STREET PLAN & PROFILE
7TH STREET
CRANFORD AVENUE
TRACT 2223
HORIZ. SCALE 1" = 40' VERT. SCALE 1" = 4'

NO. R-464
SHEET 2 OF 2

STREET PLAN & PROFILE
ALLEY
TRACT 2223
 HORIZ. SCALE 1"=10' VERT. SCALE 1"=2'

APPROVED BY: [Signature]
 Director of Public Works
 DATE: May 18, 1961
 NO. R-464
 SHEET 1 OF 2

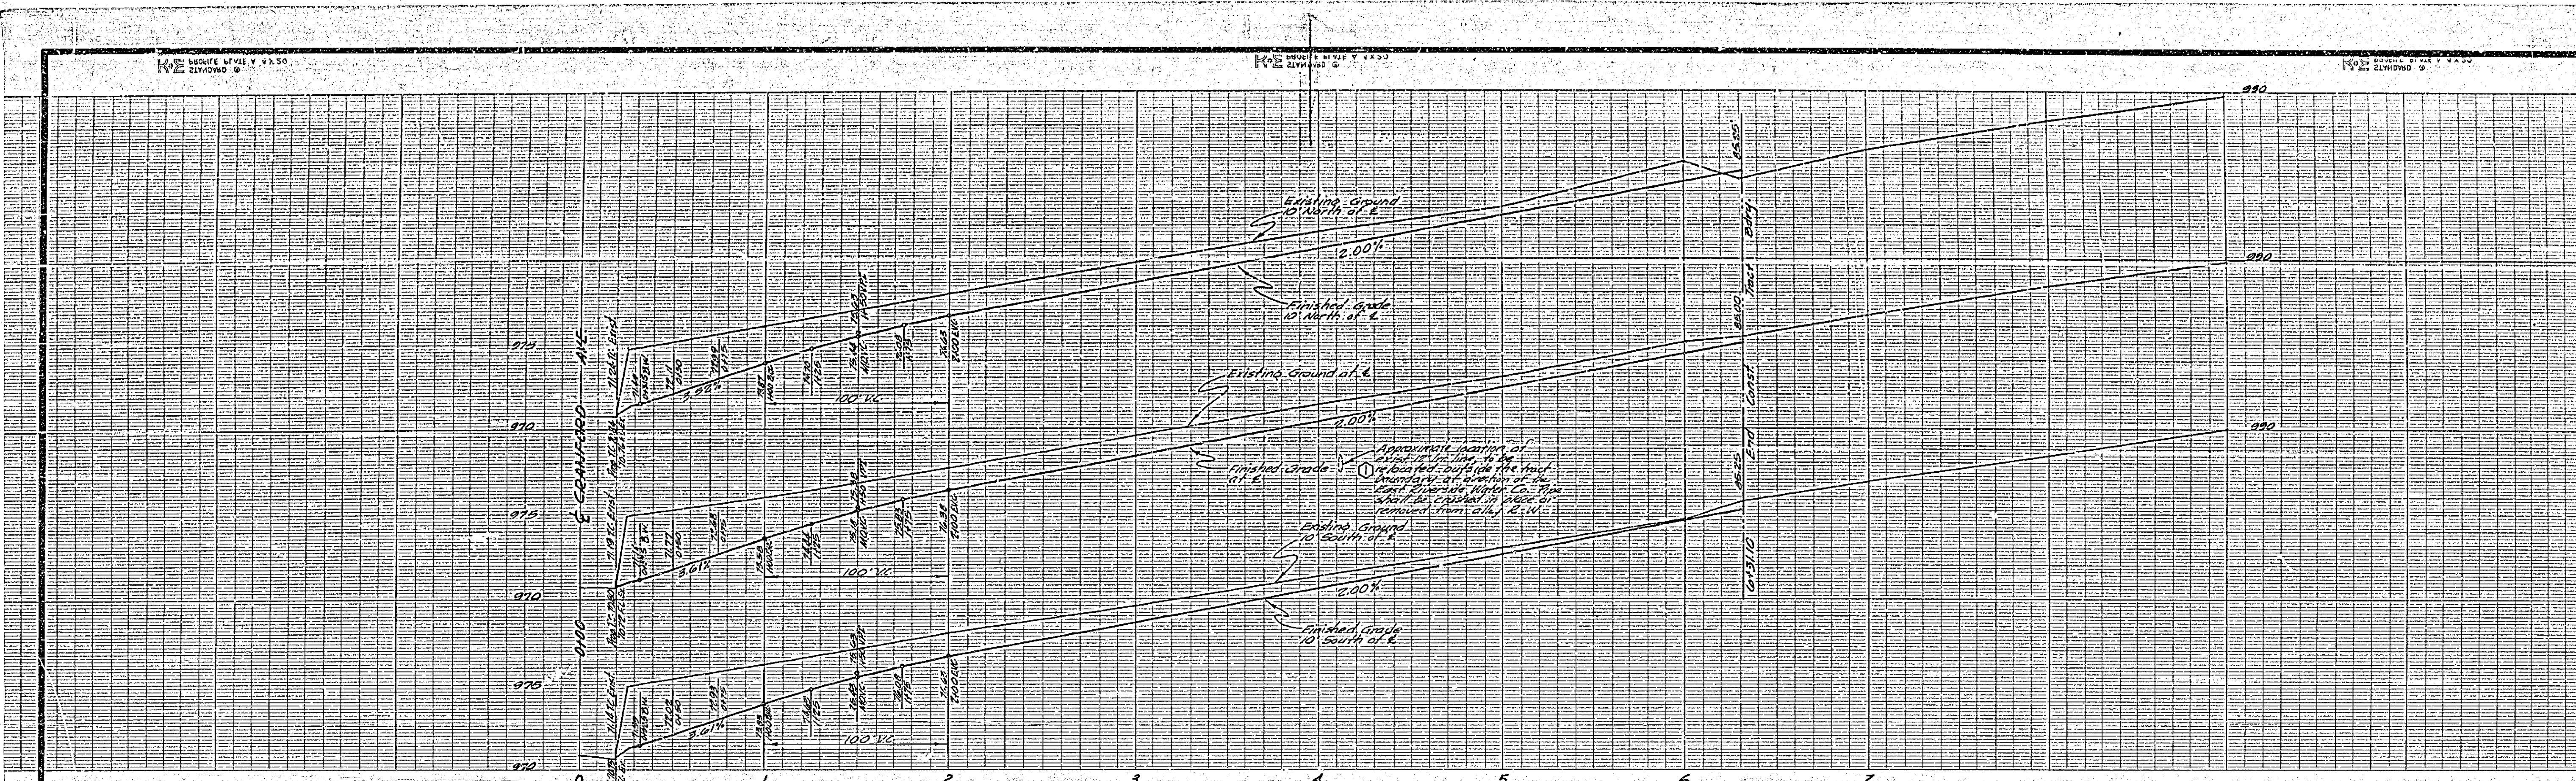
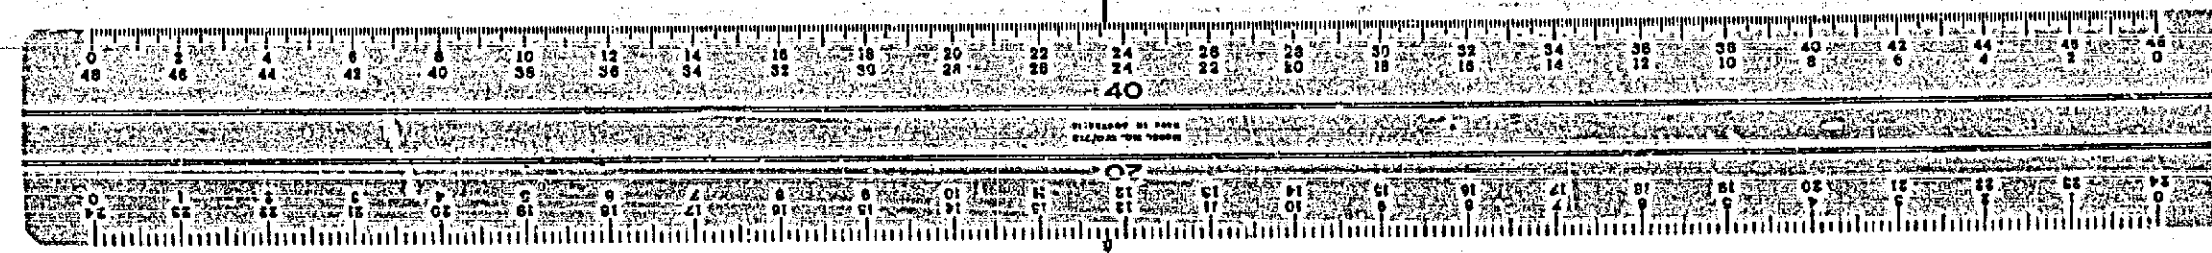
REVISIONS	
MARK	DESCRIPTION
1	12-23-61 12" irrigation line changed to 18" irrigation line and enclosure deleted.

DETAIL
 Showing Encasement of Existing 12" Irrigation Line
 NOTE: Encasement shall extend to two feet back of curb & toward alley edges

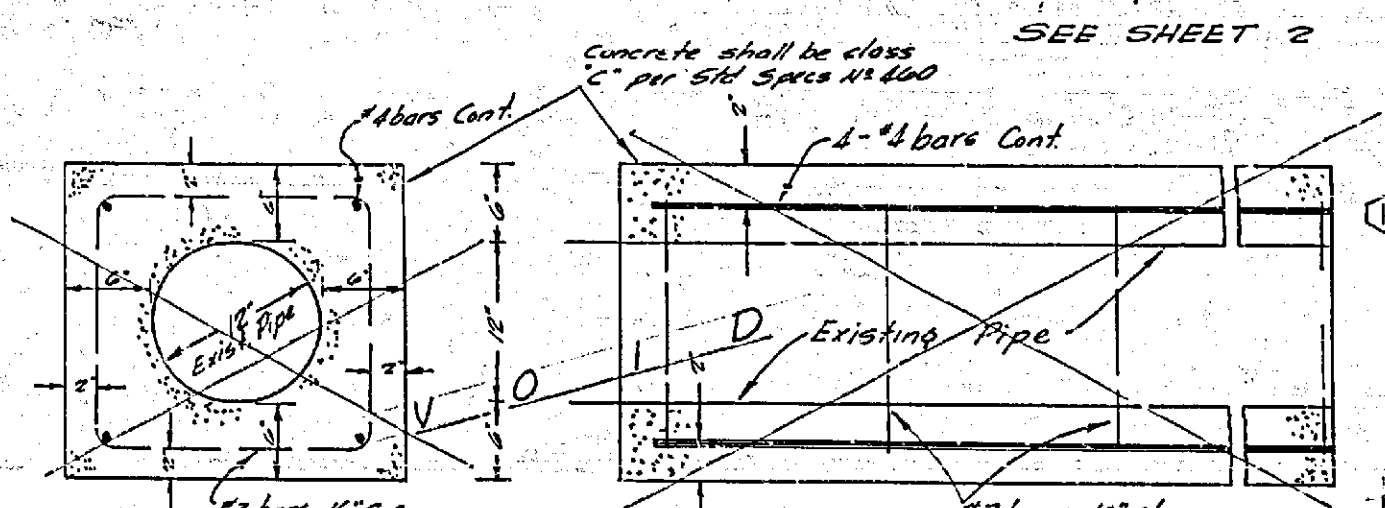
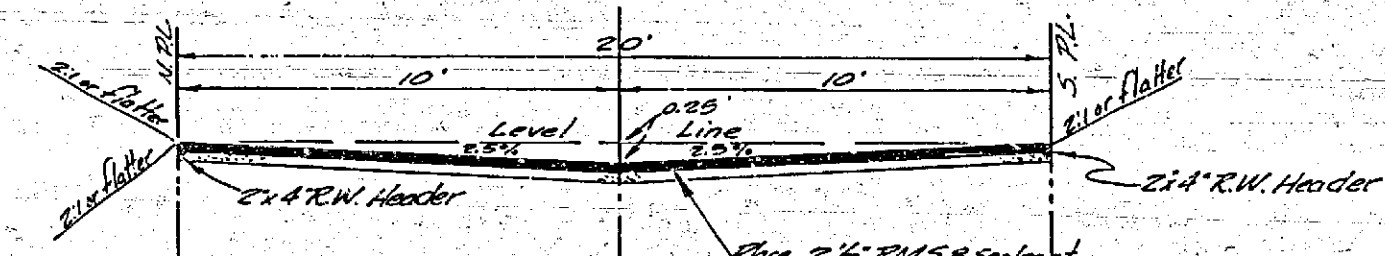
Existing 12" Irrigation Line to be relocated outside the street boundary on the NE corner of the East Riverside Water Company. Res shall be crushed in place or removed from Alley 100'

REVISIONS		
MARK	DATE	DESCRIPTION
①	5-29-61	Note to encase 12" VC in place changed to relocate etc. [Signature]
